Environmental Assessment

**Transuranic Waste Retrieval from the 218-W-4B and
218-W-4C Low-Level Burial Grounds, Hanford Site,
Richland, Washington**

U.S. Department of Energy
Washington, D.C.

March 2002

Figure 8. TRU Waste Retrieval Flow Diagram.
(The order or steps may change depending on operational conditions)

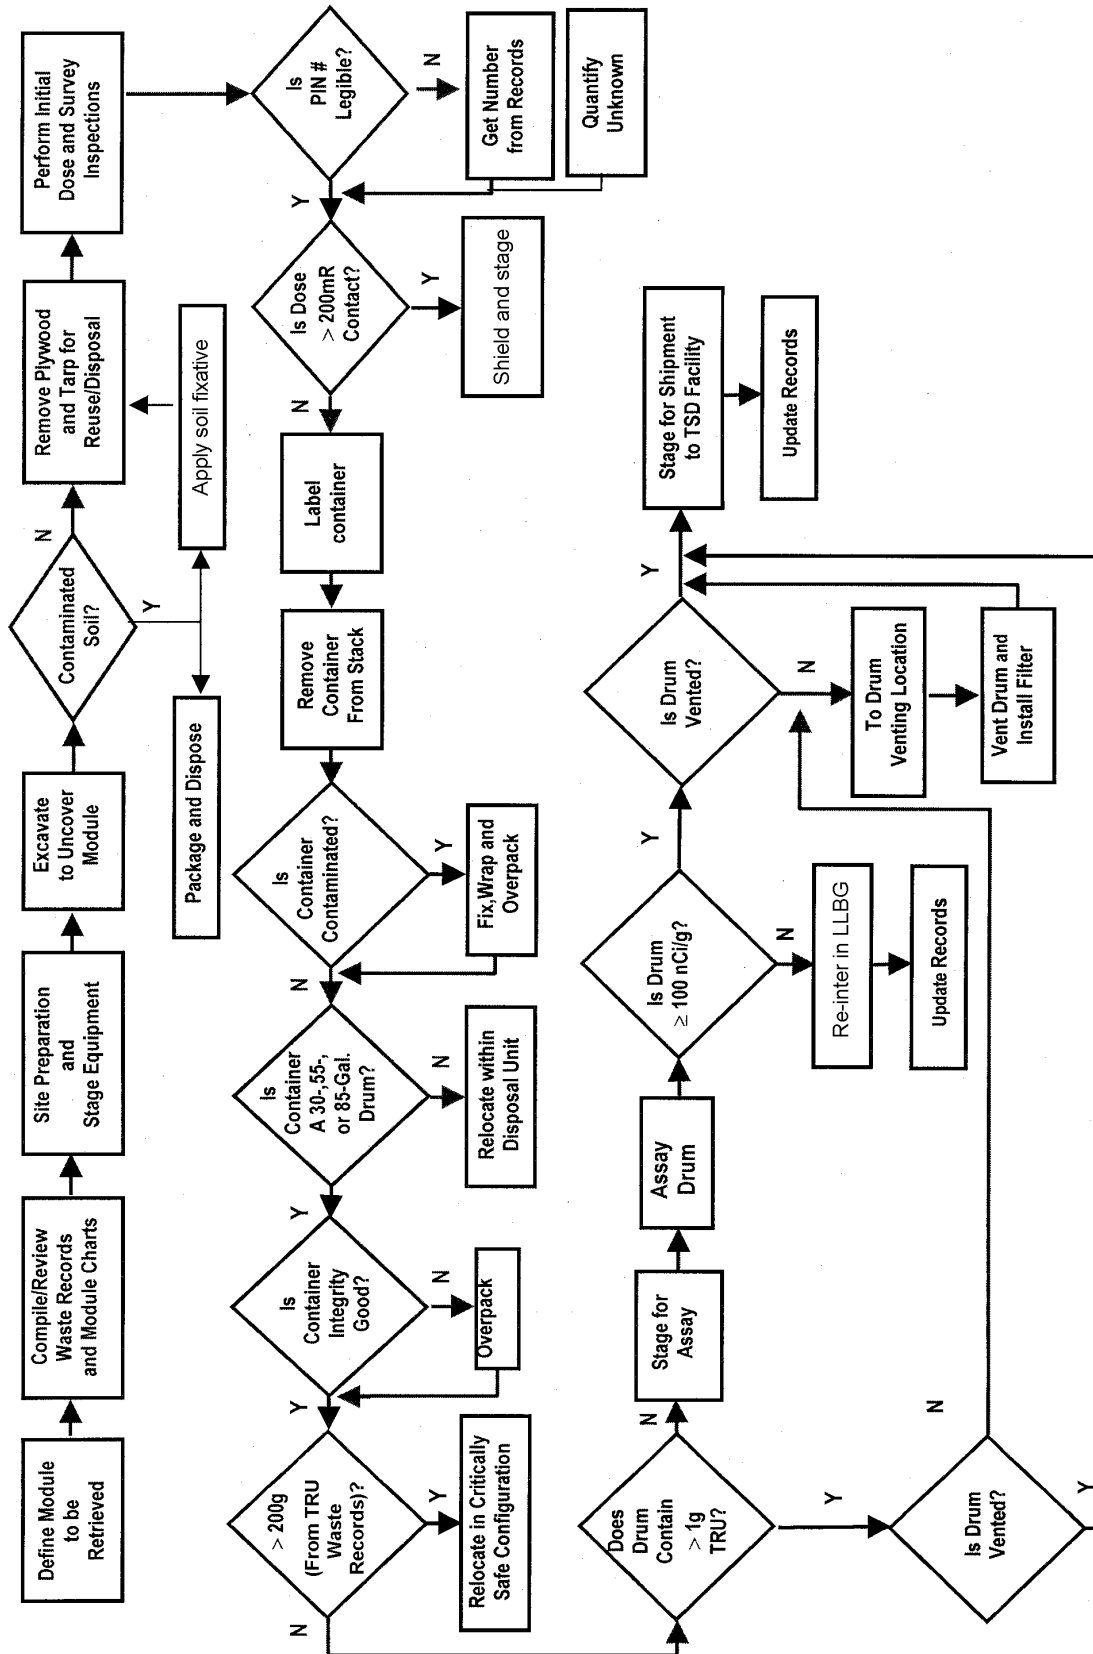
As listed in **Section 2-1 PROPOSED RECORDS REVIEW, LLBG UPGRADES, AND STAGING OF EQUIPMENT** in the **third paragraph** (and in Figure 10, the flow chart), review of the record information is vital to identification of the contents in the pits. However, the following final sentence of **paragraph two** warns that records may be compromised. "Because of waste management requirements and practices from before the mid-1980's, it is anticipated that storage/burial records for some containers might be incomplete or missing." The Tribe suggests that responsible record keeping of the contents of the assayed containers during this proposed action is a critical element of the action, and that a module **addressing current record keeping** be added to end of the flow diagram to prevent incomplete or missing records in the future.

Transuranic waste removed from the 218-W-4B and 218-W-4C burial grounds will be subjected to the same rigorous record keeping requirements and acceptance review as similar wastes generated elsewhere on the Site and placed into storage at Hanford Site TSD units. Records that will be retained for removed containers include: contents inventory records, waste acceptance checklist, designation worksheets, analytical data, radiological calculations, verification documentation, and any documentation associated with specialty reviews. To indicate this, a box labeled "Update Records" has been added after the step "Stage for Shipment to TSD Facility" in Figure 10.
